**DEVIATION REQUEST** (Attach diagrams, figures, and other documentation to clarify request)

A deviation from the standards of or in Section **2.2.4.B.5 for Roadway Cross Sections** of the Engineering Criteria Manual (ECM) is requested.

# SOLACE APARTMENTS

## PAONIA STREET

Figure 2-15. Typical Urban Residential Collector Cross Section

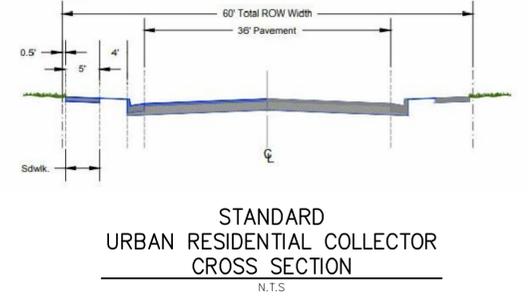
The reason for the requested deviation of an alternate road section is that Paonia Street to the north and south of the development exists as a 60' ROW with 36' (lip-lip) pavement area. The proposed design is to maintain a consistent section through the Solace development and the entire Paonia corridor while still providing the requested 80' ROW.

The proposed alternative is for Paonia Street to have an 80' ROW but the same road section as the "Typical Urban Residential Collector Cross Section" listed in Chapter 2, section 2.2.4.B.5 of the ECM.

The ECM standard is inapplicable to the particular situation due to the fact that existing Paonia Street to the north and south of the development have 60' ROW with road section "Typical Urban Residential Collector Cross Section" listed in Chapter 2, section 2.2.4.B.5 of the ECM.

This deviation will produce a development that interconnects with existing Paonia Street's typical corridor to the north and south. The standard section would unnecessarily interrupt the continuity along Paonia Street.

Figure 2-14. Typical Urban Nonresidential Collector Cross Section

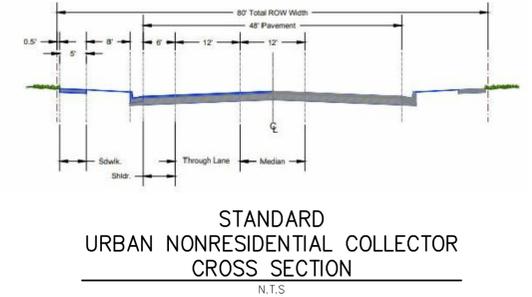
An ECM criterion for an 80' ROW width typical section includes 48' of pavement (lip-lip) typical, typical curb and gutter, and 8' tree lawns with 5' detached sidewalks.
